From: Skaggs, Pam
Sent: Tuesday, July 21, 2015 10:33 AM
To: Keen, Shelley
Cc: Fritschle, Carter; Visosky, Steven
Subject: Updated POD & POU shapes for 22-10022, Jack E & Johnnie M Koon **SK Project #1515 Completed**
Attachments: 22-10022_PD-and-shapefile-error_presentation.pdf; Madison-Co-Assessor_RP05N39E182416_Carol-Koon.pdf; Madison-Co-Assessor_RP05N39E182404_Jack-Koon.pdf; Google Earth View of 22-10022.jpg

RE: PD & Shapefile error: 22-10022, Jack E & Johnnie M Koon

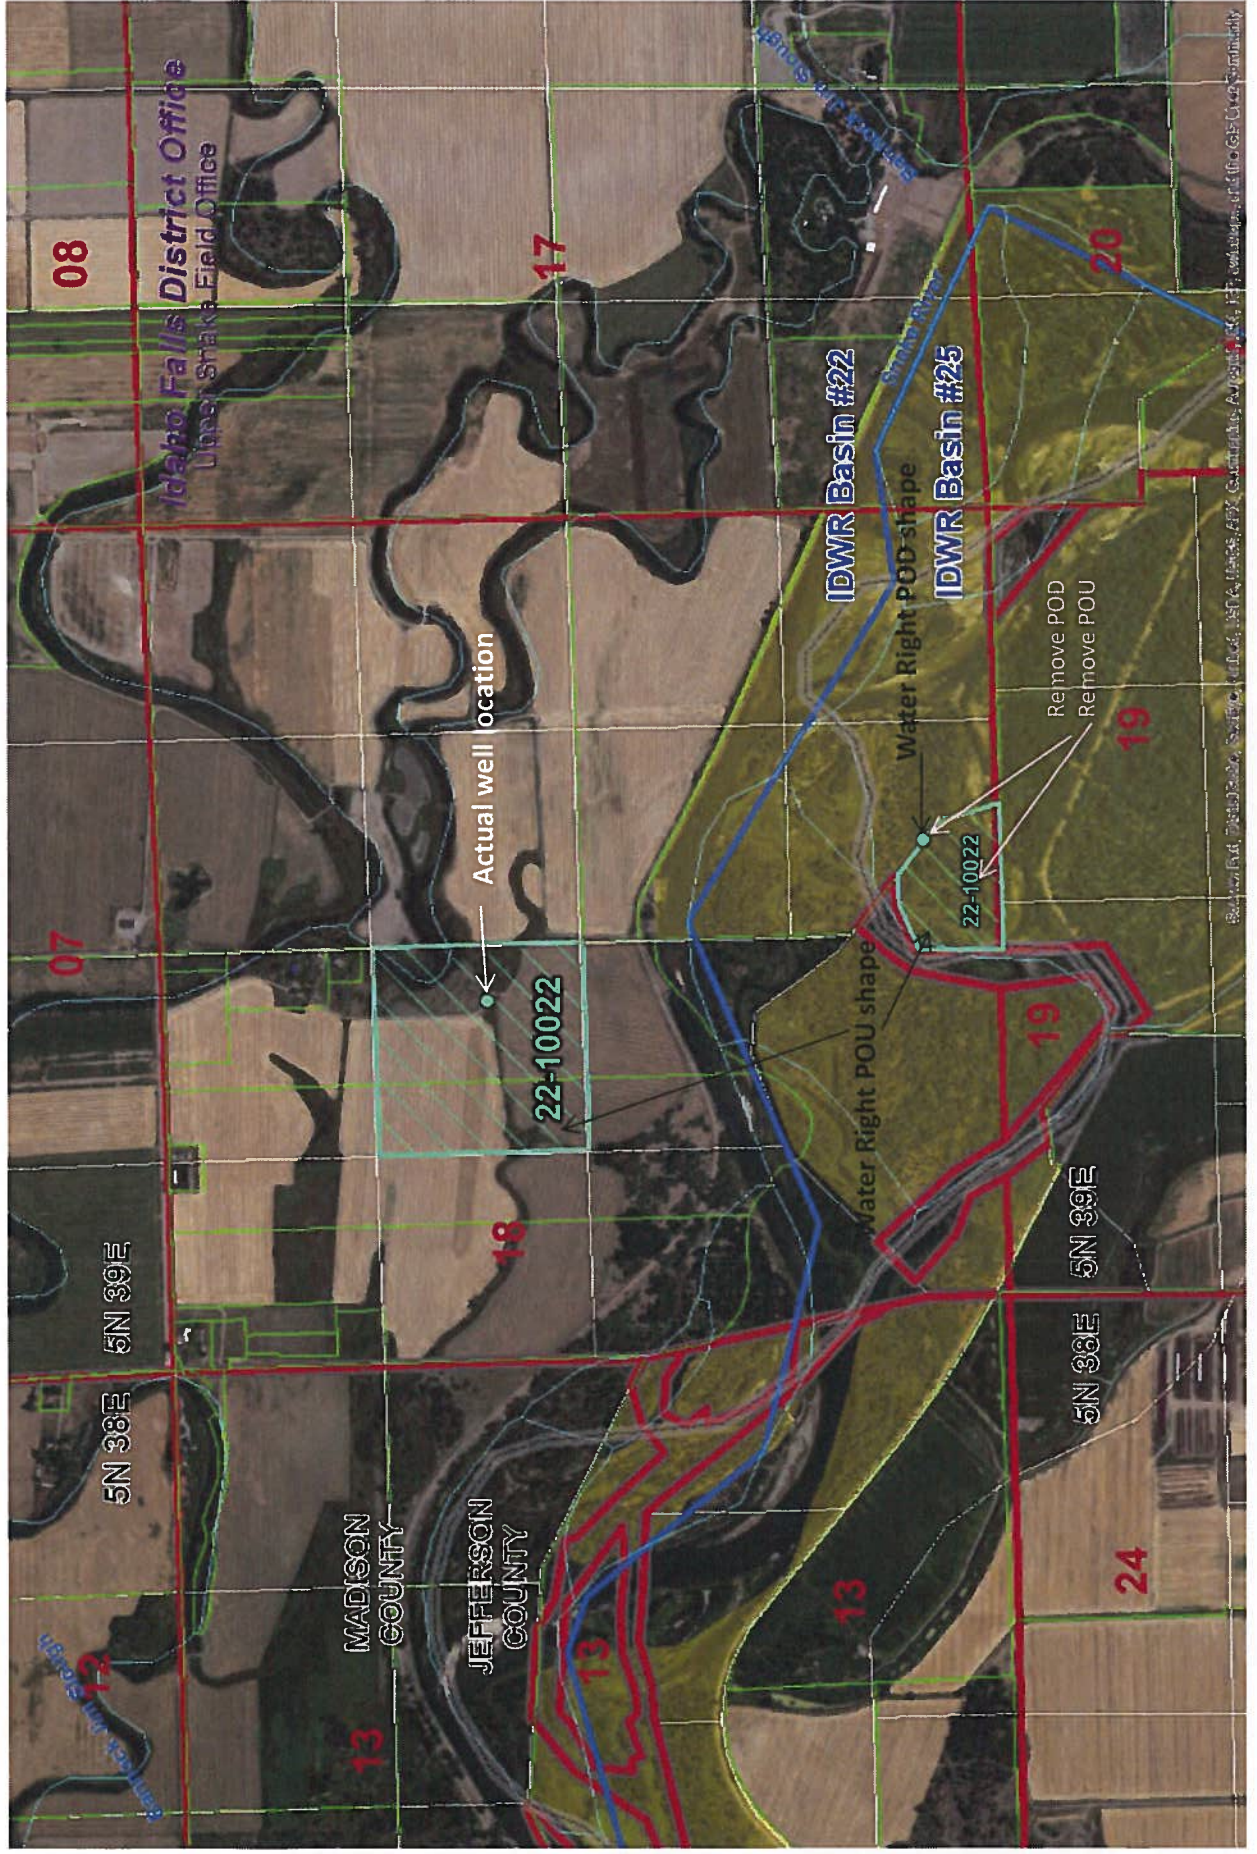
The Water Right POD shapefile for 22-10022 describes the POD in the SWSE, S18, T05N, R39E, however the SRBA Partial Decree (PD) describes it in the NESENW.

You can see the well house in aerial photography which shows it in a different 10 acre tract (SESENW) than is listed in the PD (NESENW).

The Water Right POU shapefile for 22-10022 contains two polygons: (1) describes the aliquot parcel SENE (correct); and (2) describes government surveyed Lot 6 which is a portion of the SWSE.

Explanatory material describes the tax parcel number associated with 22-10022 to be RP05N39E182401A. This parcel number doesn't show up in Madison County data currently, so perhaps 2401A was subdivided? The Madison County Assessor's Office lists Jack Koon's property within the SENW as being parcel number RP05N39E182404.

The shapefile for Jack's water right 22-10022 should probably not include Carol Koon's parcel.

-this parcel # doesn't exist anymore

(1) The Water Right POD shapefile associated with 22-10022 should change the location of the well from SWSE to the SENW.

(2) The 10 acre tract description listed in the Partial Decree should be changed from NE to the SE.

(1) The Partial Decree for 22-10022 only includes the SENE and does not include Lot 6 (SWSE), therefore the Water Right POU shapefile for 22-10022 should be edited to exclude Lot 6 (SWSE).
